STATE OF OHIO
CITY OF CANTON
STA-0153-01.70
MAHONING ROAD NE
ROADWAY IMPROVEMENTS
G.P. 1103

THE PROJECT WORK INVOLVES THE IMPROVEMENT OF APPROXIMATELY 0.67 MILES OF MAHONING ROAD NE, S.R. 153 BETWEEN THE GRACE AVENUE NE AND HARMONT AVENUE NE INTERSECTIONS. THE IMPROVEMENTS INCLUDE NEW STORM SEWERS, CURBS, SIDEWALKS, PLANTERS, SIGNAGE, AND STREET LIGHTING.

REVISIONS	DATE	BY
CONSTRUCTION BIDDING SET	4/21/14	GEA
ADDENDUM NO. 1	5/7/14	GEA

SCHEMATIC PLAN
 STA. 55+09 TO STA. 72+90

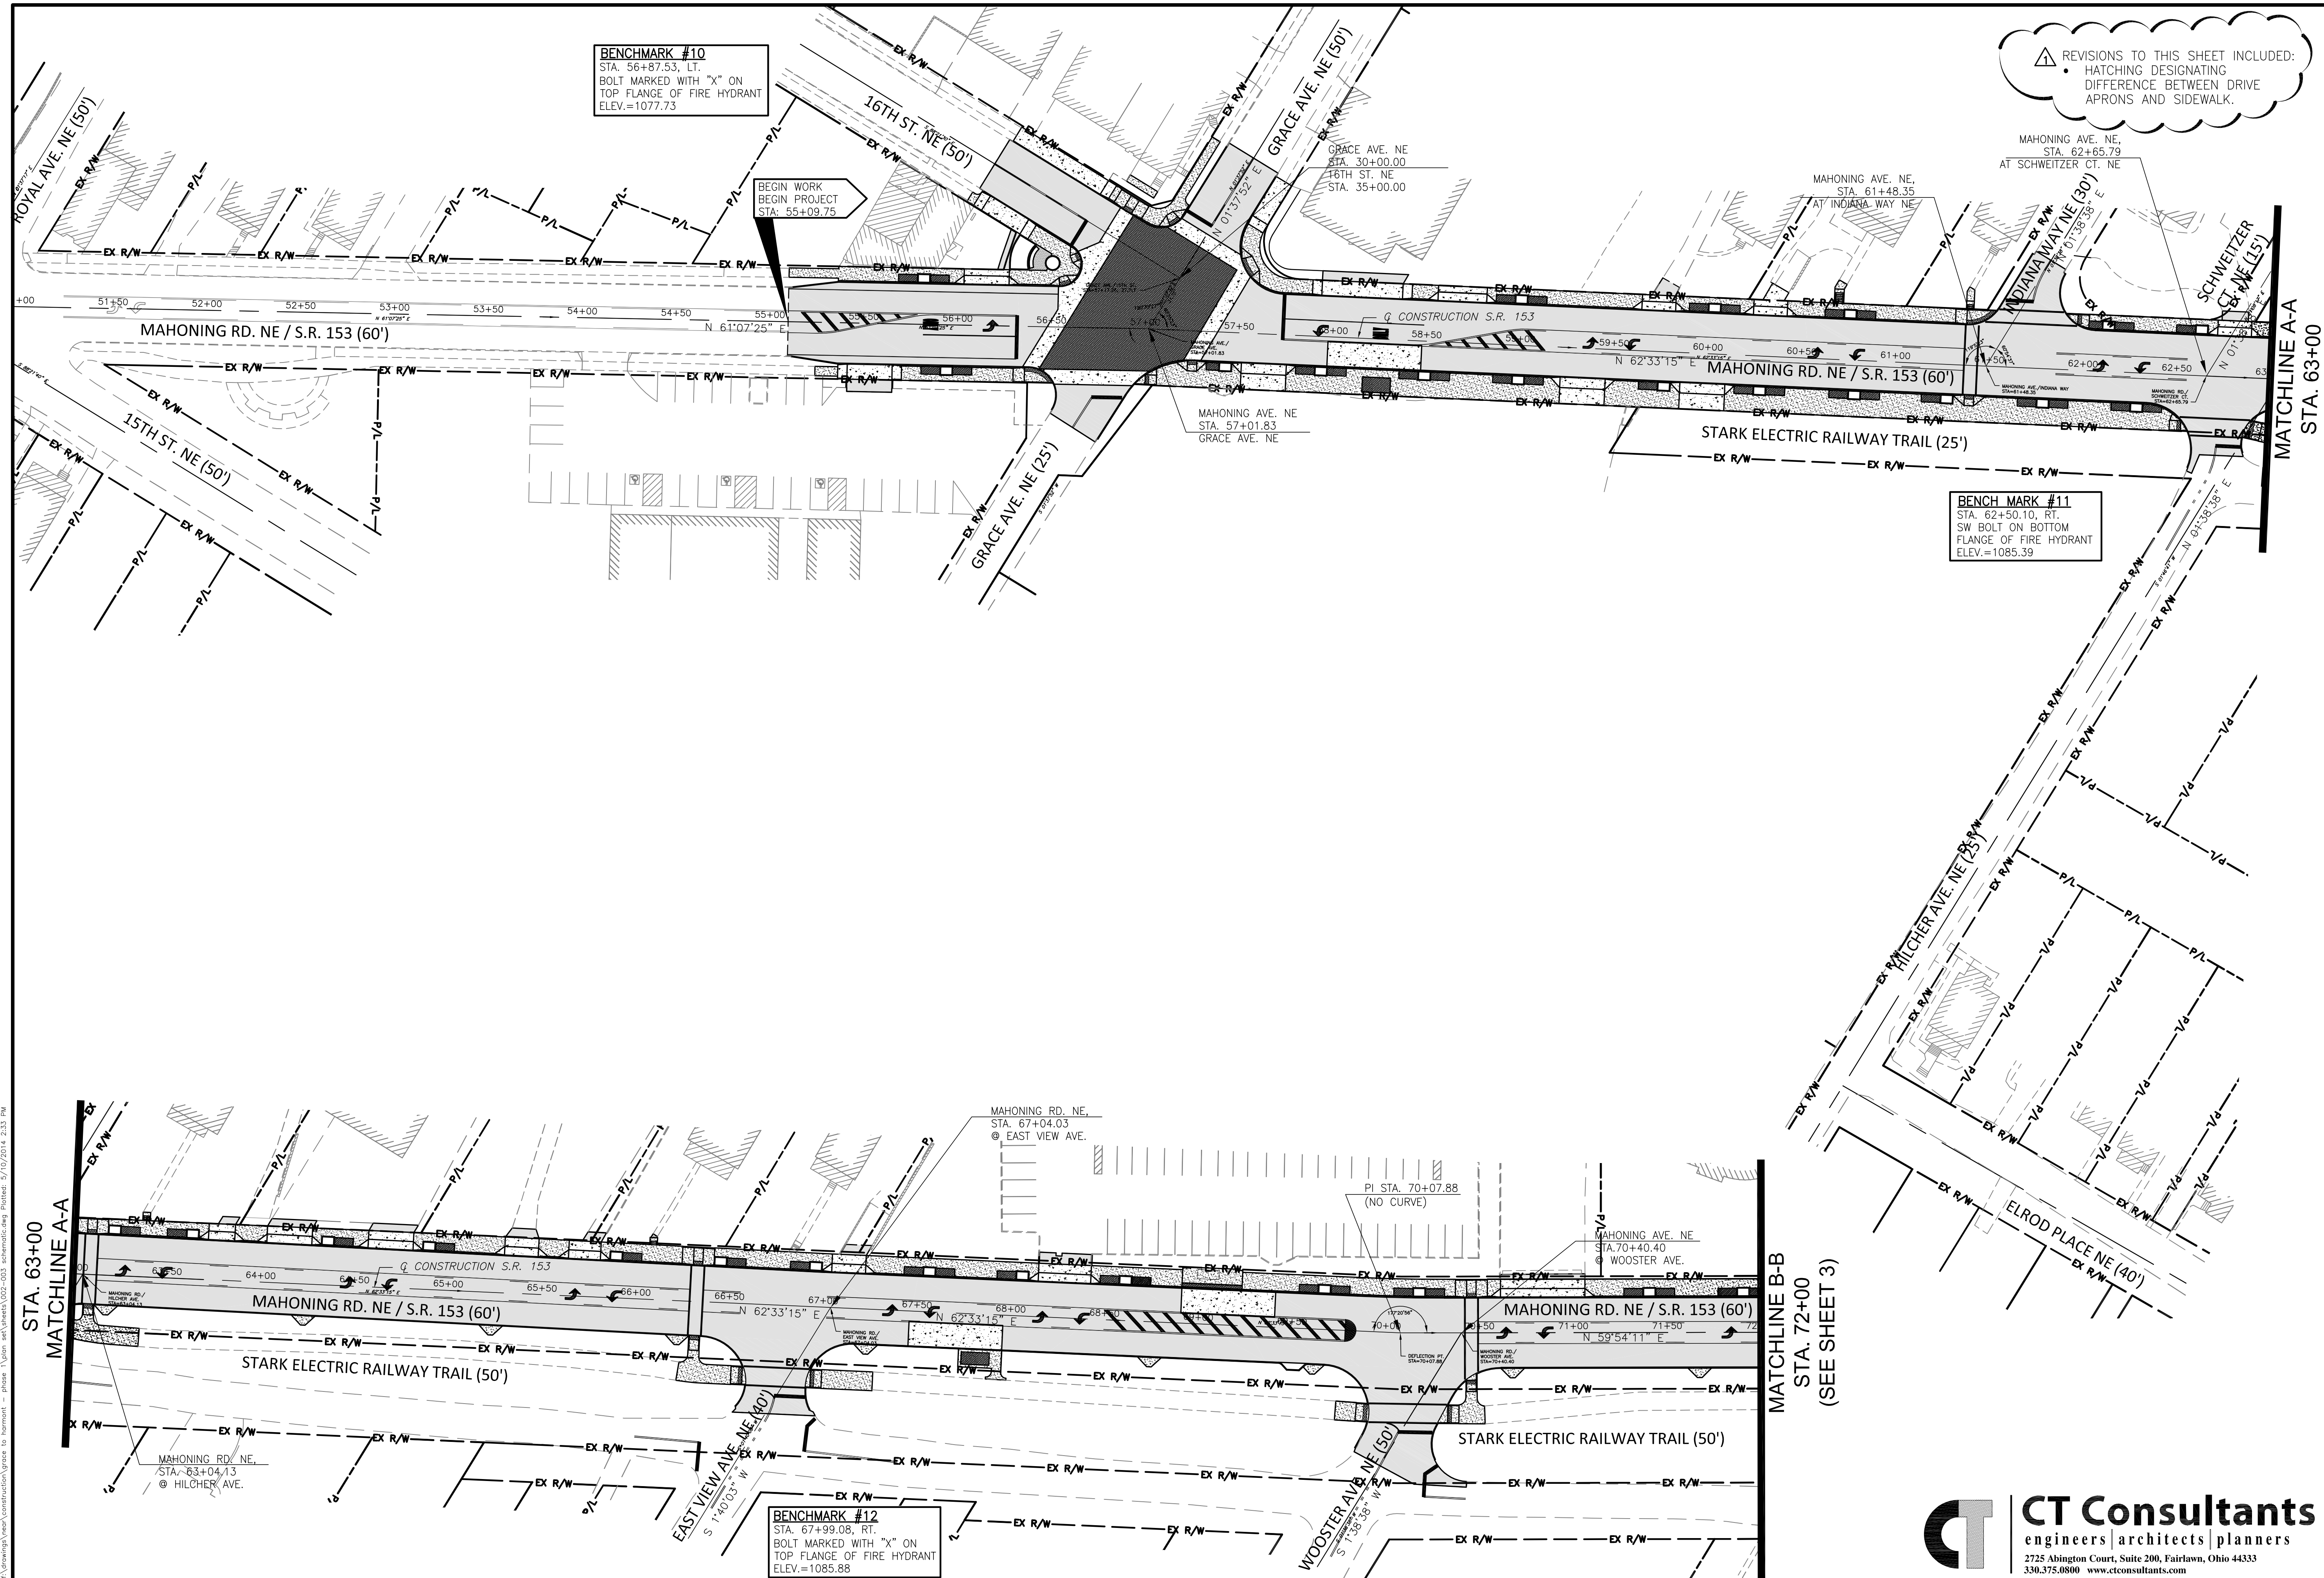
REVISIONS TO THIS SHEET INCLUDED:
 HATCHING DESIGNATING
 DIFFERENCE BETWEEN DRIVE
 APRONS AND SIDEWALK.

SCHEMATIC PLAN
 STA. 55+09 TO STA. 94+90

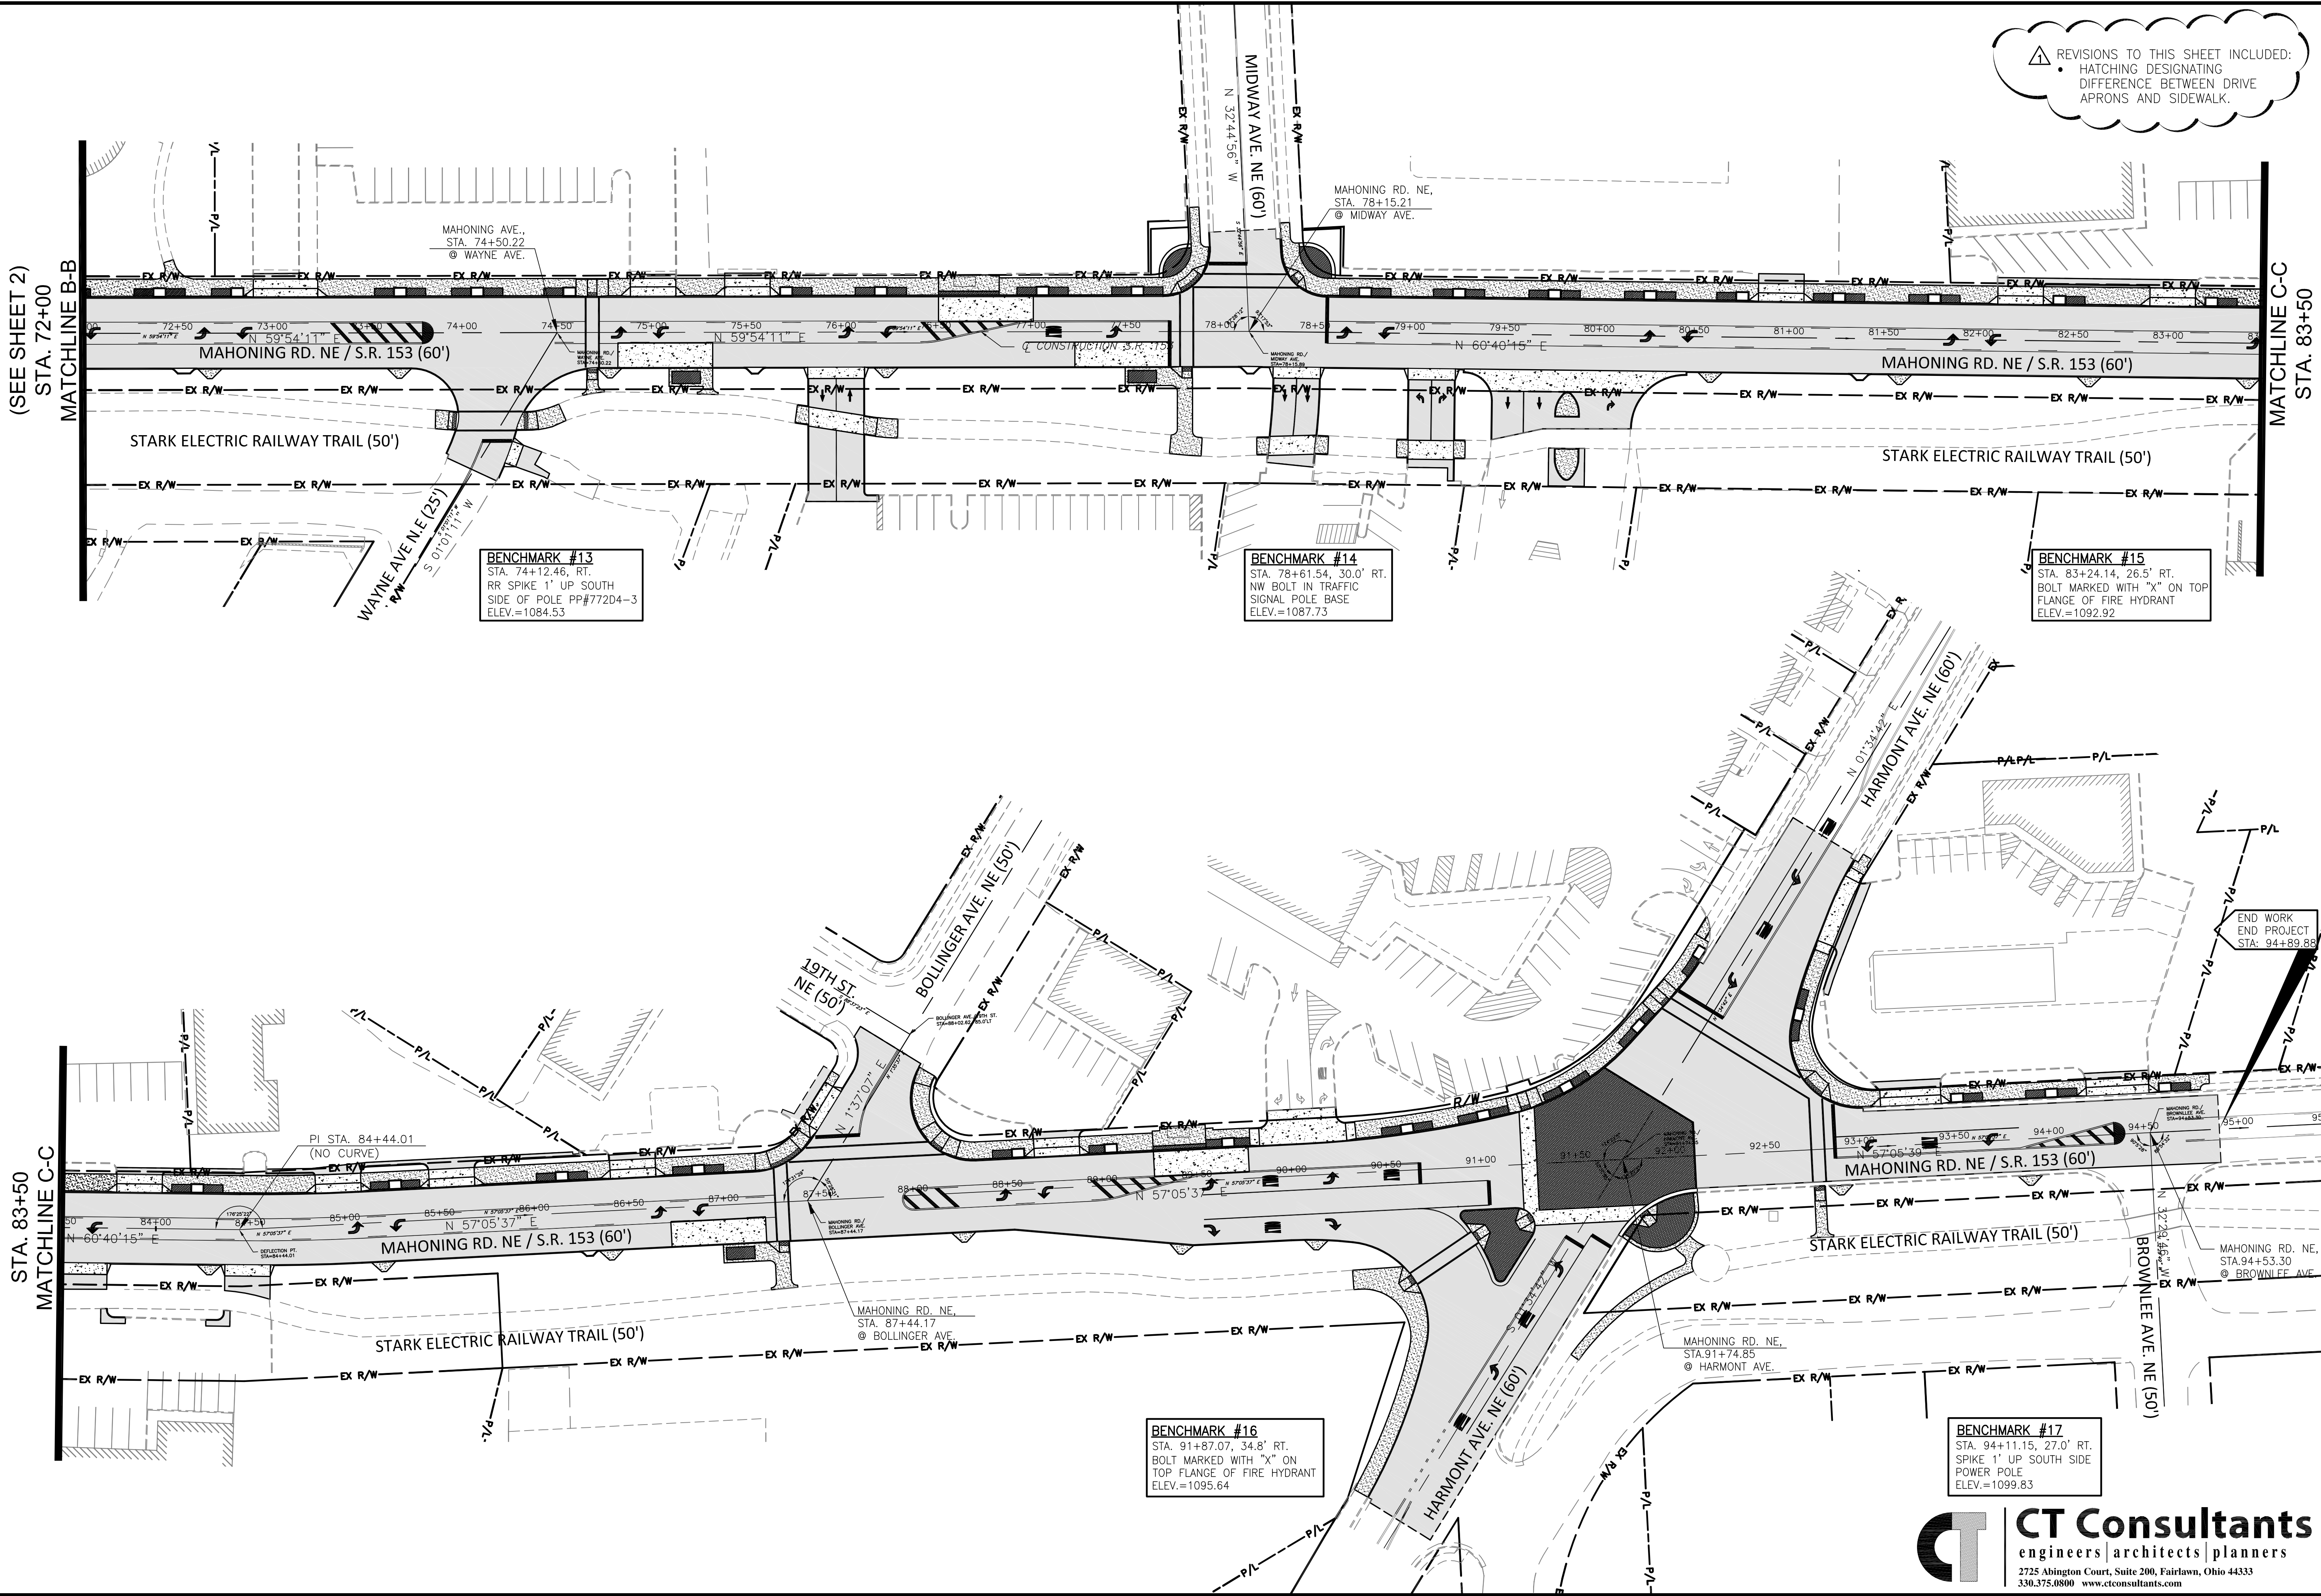
REVISIONS TO THIS SHEET INCLUDED:
 HATCHING DESIGNATING
 DIFFERENCE BETWEEN DRIVE
 APRONS AND SIDEWALK.
